# Site Accessibility Evaluation

## Costilla Parking Garage

50 E Costilla St  
Colorado Springs, CO  
80903

Accessibility Evaluation

Finding 297249 Main Photo

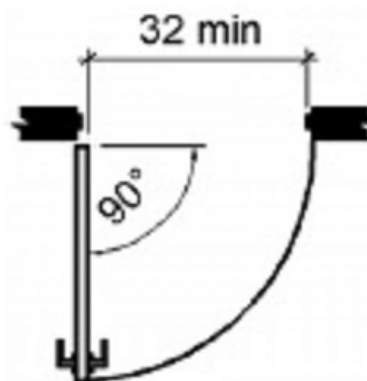
The door opening does not provide at least 32 inches between the face of the door and the opposite stop.

25.25 inches in width.  
Door located on  
northeast corner of  
Tejon and Costilla

Install door frame and door that provides a minimum width of 32 inches. Projections into the clear opening width between 34 inches and 80 inches above the finish floor or ground shall not exceed 4 inches.

Finding 297250 Main Photo

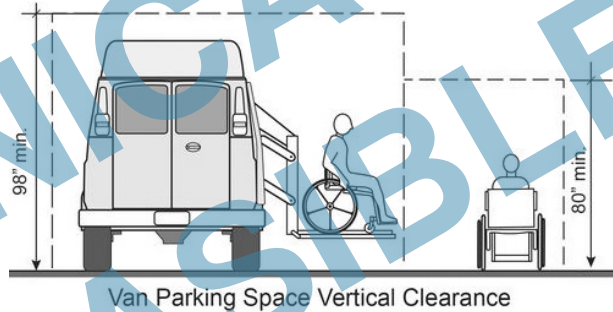
The vehicle route to the accessible parking contains vertical clearances less than 98 inches.

Parking structure  
height clearance  
maximum is 86 inches

At the moment there are no plans in constructing a new structure. Will address ADA parking to the maximum extent possible for compliance.

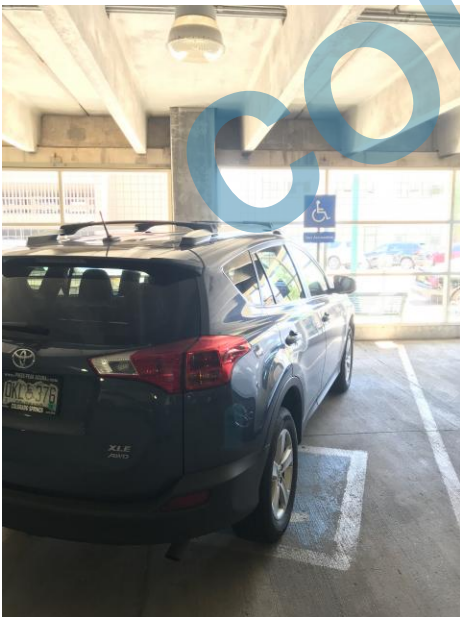
The access aisle is missing at the accessible parking stall.

Access isle missing for 2nd accessible van parking stall

Re-configure striping to ensure 2 van stalls with 2 access aisles to the right of each van stall and 7 accessible parking stalls with a 5 foot access aisle. Since parking stalls are angled, each van stall must have its own access aisle located on the passenger side. Non-van accessible stalls may share an access or van access aisle and access may be located on either side of the vehicle.

Finding 297287 Main Photo

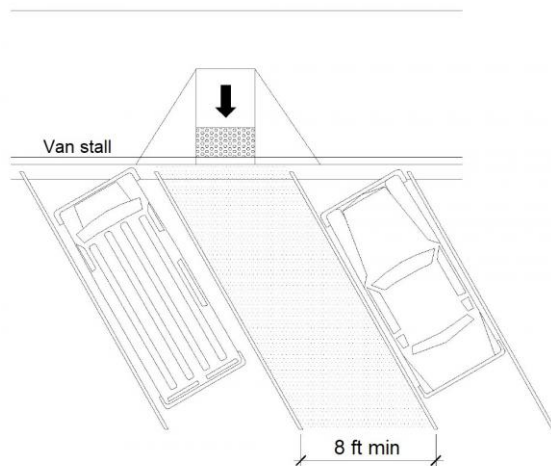
The access aisle is on the driver's side of the stall.

Access aisle on driver's side (angled parking stall)

Remove "van accessible" signage from 2nd stall. Van access aisles must be on passenger side for angled parking stalls.
